Date: May 7, 2008
Subject: LAK 44 L/A break (SR 44 Corridor Study Analysis)

Reference is made to your April, 2008 email requesting that our office review the technical memorandum for SR 44 in Lake County.

Figure 1

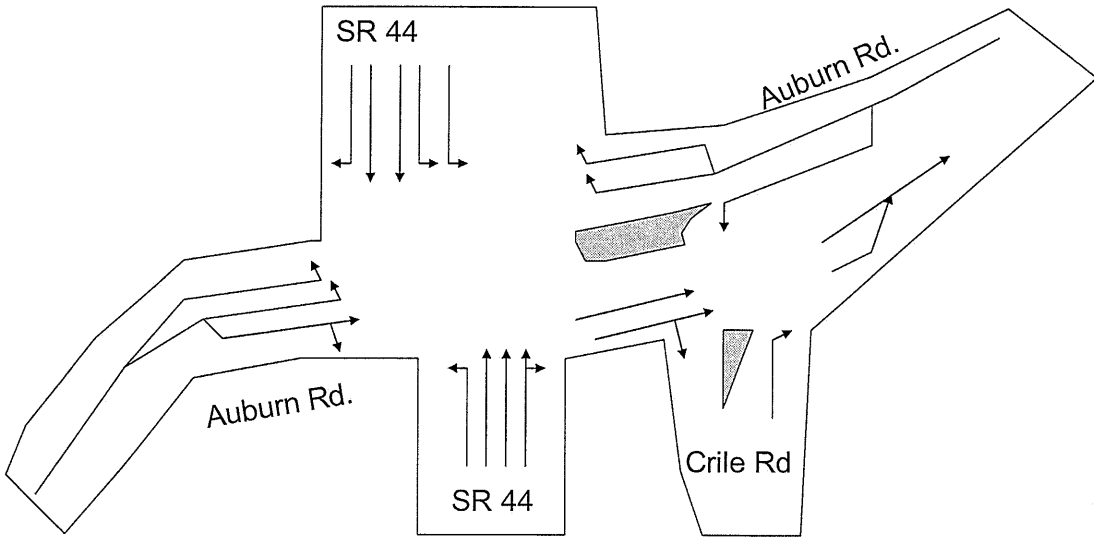
The study demonstrates that the proposed L/A break will shift traffic from Auburn Road to the new roadway connection. The study also indicated that improvements are needed through the I-90 interchange to bring it to a satisfactory operation. The study proposed a design which is not feasible. The I-90 EB loop ramp is proposed to have two lefts and two rights. This is not an acceptable design geometrically. Other interchange configurations need to be explored. Our office has provided a possible interchange configuration (Figure 1) which could provide an acceptable LOS adding fewer lanes to the interchange. It would involve adding an additional exit ramp. The ramps would function as directional ramps (northbound and southbound). Both of these ramps would be signalized. This configuration would also require widening the SR 44 northbound bridge to accept the 3rd northbound lane. This design can be phased into the Auburn road improvements. The added through lane would be required northbound beginning south of the Auburn road intersection. This would need to be developed prior to the northbound left turn at Auburn Road intersection. This lane will need to have overhead signing since it will drop to the I-90 westbound left turn lane.

Possible interchange configuration:

- Add a new EB to SB ramp
- Convert the existing EB loop ramp to NB only
- Widen bridge to allow dual left northbound; Convert SB slip ramp to right turn lane.
